Access Compliance Report

Public Rights-of-Way

Intersection ID: 52582	Main Street: NOBLES_AV	Cross Street: N/A	Location: NW
ADA ID: 540E06B96F24	Ramp Type: Perp	Initial Pass/Fail: Fail	Overall Compliance: No
Codes/Mitigation Info/Possible Solution		Field Measurements/Component Compliance	
Severity Score: 13.75

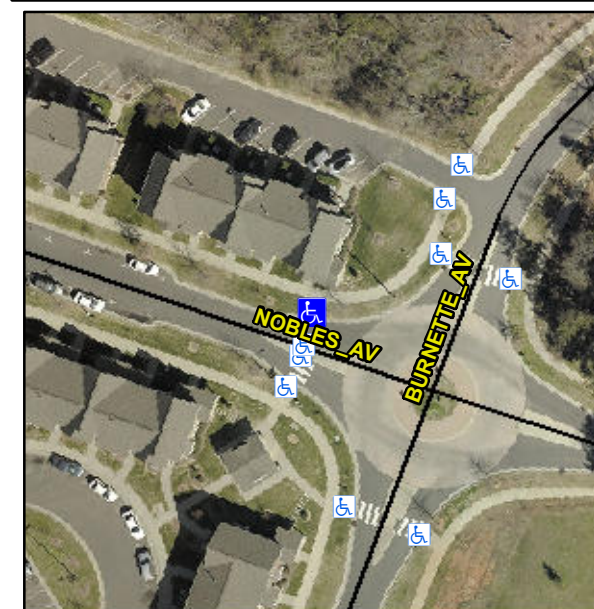
Not Found, R304.2.2, R304.5.3

Compliance	Description	Data	Compliance	Description	Data
N/A	Ramp Length (in)	80.0	No	Ramp Slope (%)	8.5
Yes	Ramp Width (in)	71.0	No	Ramp XSlope (%)	2.7
N/A	Flare Type LT	N/A	N/A	Flare Type RT	N/A
N/A	Flare Slope LT (%)	N/A	N/A	Flare Slope RT (%)	N/A
N/A	Flare Traversable LT?	N/A	N/A	Flare Traversable RT?	N/A
N/A	Landing Length (in)	N/A	N/A	DWS Provided?	N/A
N/A	Landing Width (in)	N/A	N/A	DWS Contrast?	N/A
N/A	Landing Slope (%)	N/A	N/A	DWS Length (in)	N/A
N/A	Landing X Slope (%)	N/A	N/A	DWS Full Width?	N/A
N/A	Landing Curb? (Y/N)	N/A	N/A	DWS Offset (in)	N/A
N/A	Shared Landing?	N/A			
N/A	Gutter Ponding?	N/A	N/A	Gutter Slope (%)	N/A
N/A	Gutter Lip Ht (in)	N/A	N/A	Gutter X Slope (%)	N/A
N/A	Painted X Walk1?	No	N/A	Painted X Walk2?	N/A
	X Walk 1 Direction	To S		X Walk 2 Direction	N/A
N/A	X Walk 1 Width (in)	N/A	N/A	X Walk 2 Width (in)	N/A
	X Walk 1 Slope (%)	3.5		X Walk 2 Slope (%)	N/A
	X Walk 1 X Slope (%)	3.4		X Walk 2 X Slope (%)	N/A

Remove & Replace Entire Ramp.
